PIC16CR72 Rev. A Silicon Errata Sheet

The PIC16CR72 (Rev. A) parts you have received conform functionally to the Device Data Sheet (DS39016A), except for the anomalies described below.

FIGURE 1: WRITES TO TIMER1 (EXTERNAL CLOCK / OSCILLATOR MODE)

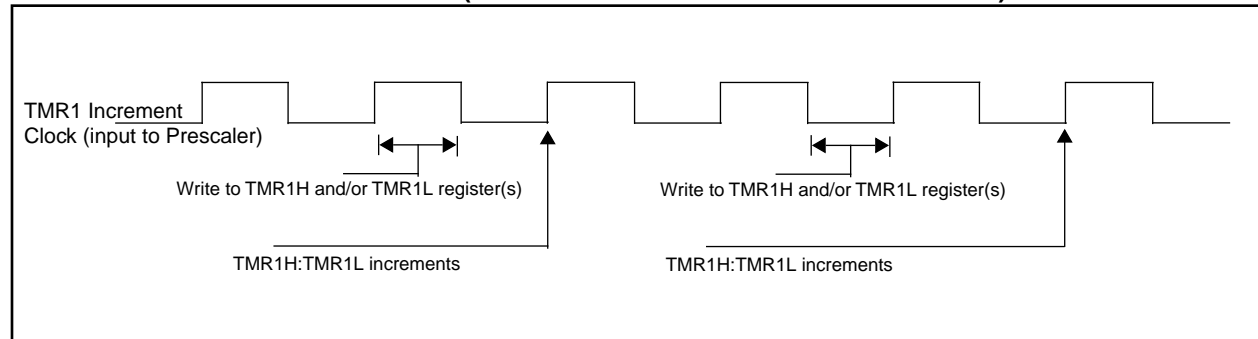
- a) The operation of Timer1 needs some clarification when the timer registers are written when the TMR1ON bit is set.

The internal clock signal that is the input to the TMR1 prescaler affects the incrementing of Timer1 (TMR1H:TMR1L registers and the Timer1 prescaler). When the Timer1 registers are NOT written, the Timer1 will increment on the rising edge of the TMR1 increment clock.

When the TMR1H and/or TMR1L registers are written while this clock is high, TMR1 will increment on the next rising edge of this clock.

When the TMR1H and/or TMR1L registers are written while this clock is low, TMR1 will not increment on the next rising edge of this clock, but must first have a falling clock and the rising clock for TMR1 to increment.

Figure 1 shows the two cases of writes to the TMR1H and/or TMR1L registers. Due to the V_{IH} and V_{IL} thresholds on the oscillator/clock pins, external Timer1 oscillator components, and external clock frequency, the Timer1 increment clock may not be of a 50% duty cycle.

The TMR1 increment clock is out of phase of the T1OSO/T1CKI pin by a small propagation delay.
